AGENDA
PLANNING COMMISSION
116 WEST NEEDLES
BIXBY, OKLAHOMA
February 17, 2015 **6:00 PM**

**MINUTES
PLANNING COMMISSION
116 WEST NEEDLES
BIXBY, OKLAHOMA
January 20, 2015 6:00 PM**

To: Bixby Planning Commission
From: Erik Enyart, AICP, City Planner
Date: Thursday, January 08, 2015
RE: Report and Recommendations for:
Final Plat of “Seven Lakes V”

Exhibit "A.2"
Quail Creek of Bixby
General Utility Easement
Exhibit

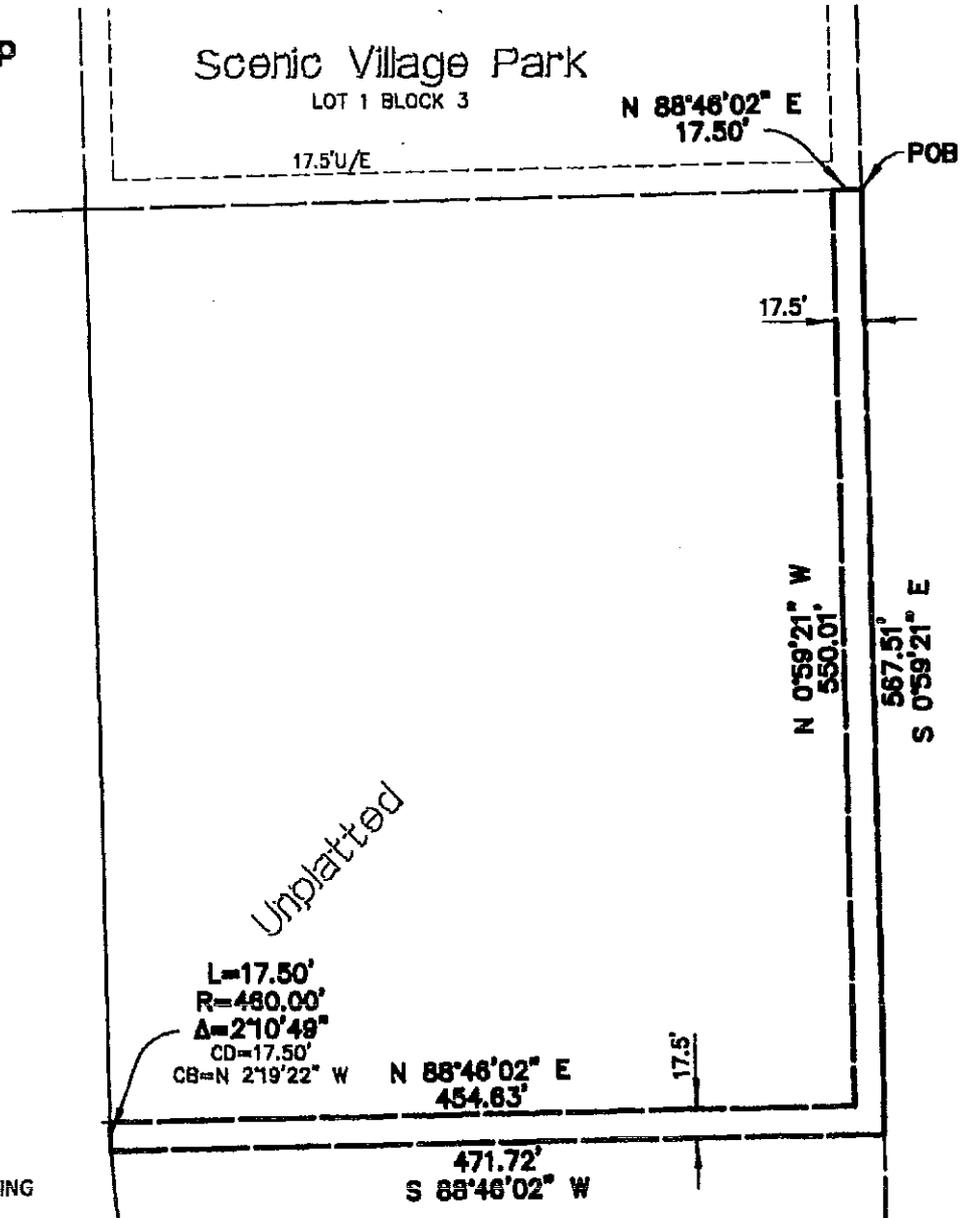
However, based on plans provided by Tanner Consulting, LLC on the date of this report, the "loop" is now planned to be entirely underground, save for the first approximately 1,100' extending south from 121st St. S. This 1,100' includes (1) Lot 1, Block 3, Scenic Village Park and (2) the proposed Lot 1, Block 1, "Quail Creek Office Park." A copy of the exhibit received on this date is attached to this report.

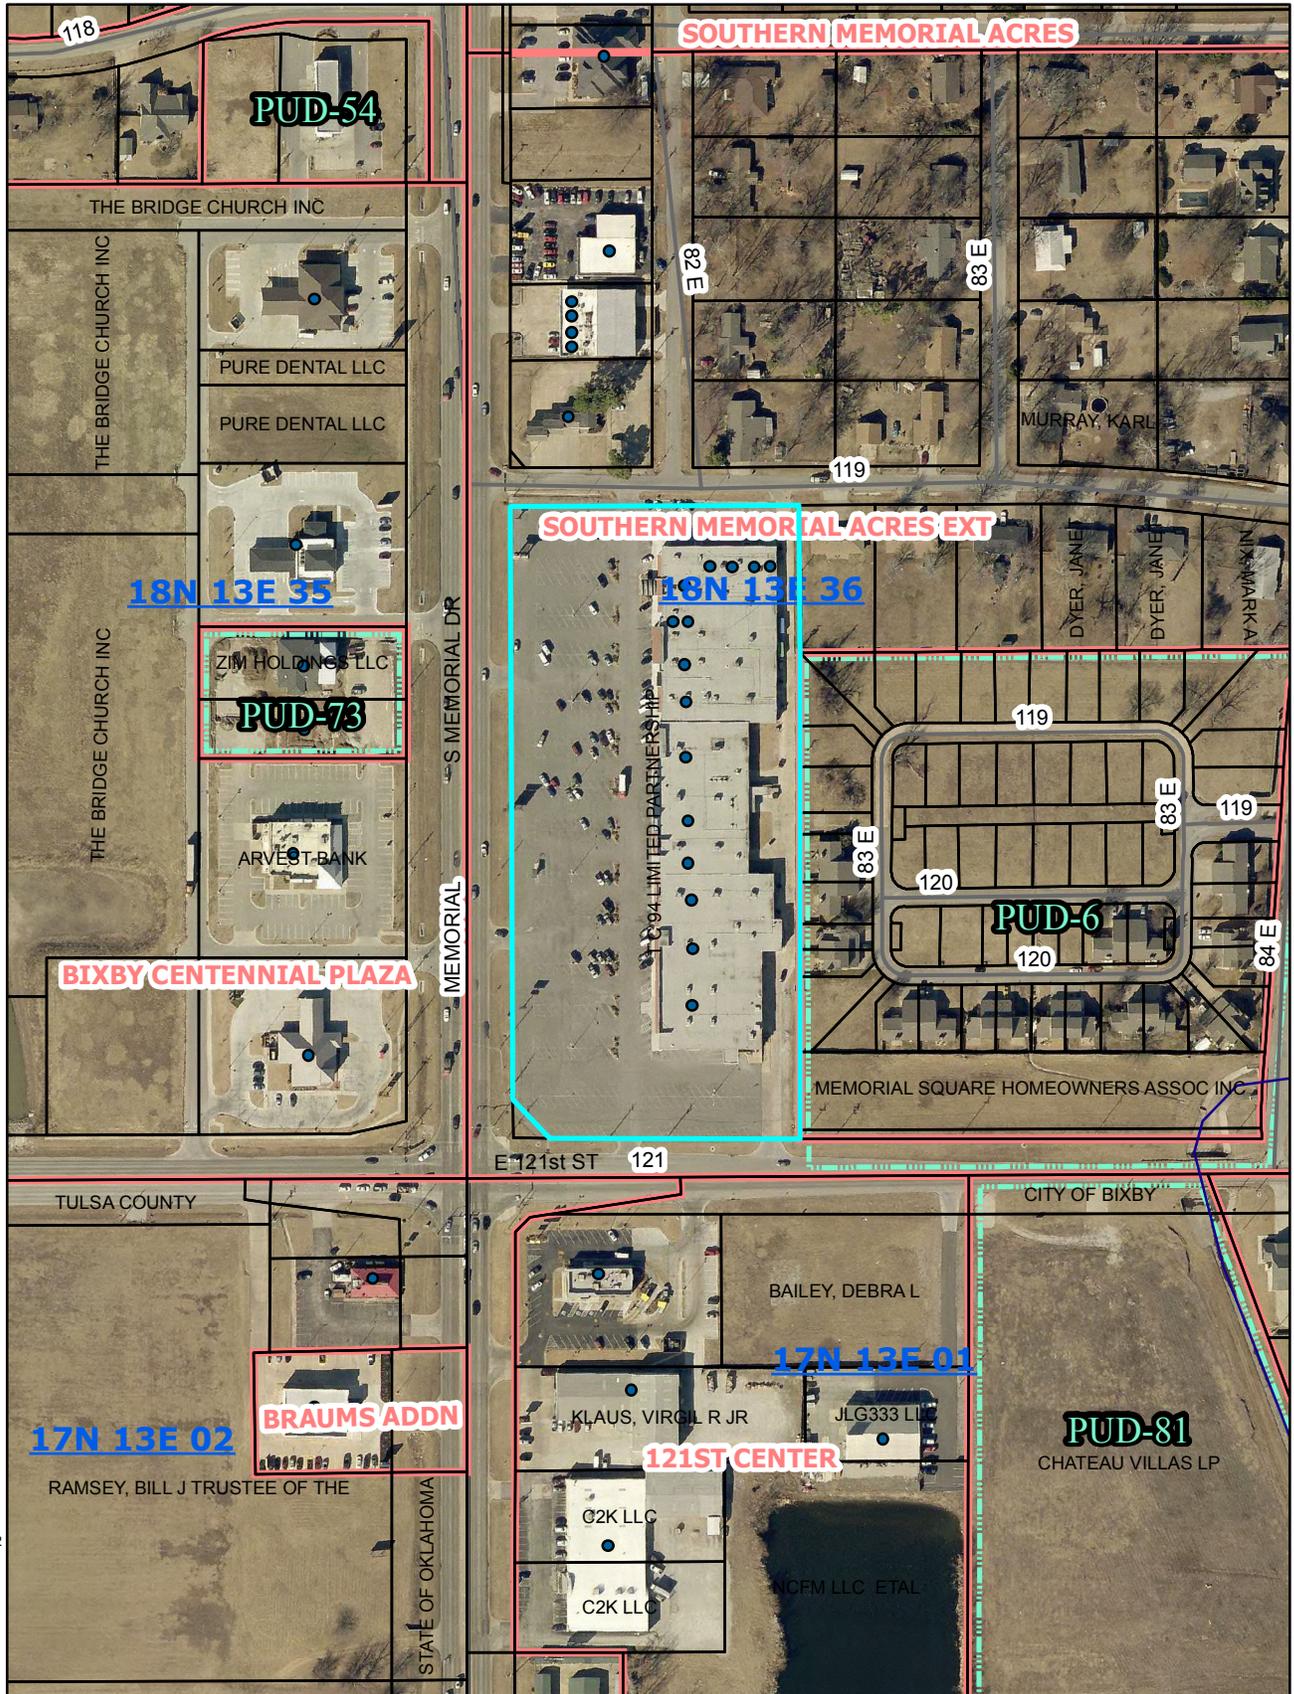
General. The Applicant is seeking Lot-Split approval to separate the southerly approximately 2.012 acres (now, approximately 2 acres), containing the southernmost tenant space in the shopping center, the former *May's/Drug Warehouse* store site addressed 12037 S. Memorial Dr., to allow for its replacement with a new Use Unit 14 *QuikTrip* convenience store / gasoline service station.

The proposed tract complies with all the bulk and area standards of the CS district. For the new, standalone store building and for the reconstructed southern wall of the *Kelly-Moore Paints* tenant space, which will have an approximate 4' setback from the proposed common line, the CS district requires no setbacks. The Applicant has informed Staff that they are working with the shopping center owner on private agreements necessary to facilitate the reconstruction of the shopping center's new south wall and other arrangements necessary to allow the shopping center to continue to function upon the separation of the proposed *QuikTrip* redevelopment tract. All existing and proposed buildings appear to comply with the zoning setback requirements of the CS district upon the approval of this Lot-Split.
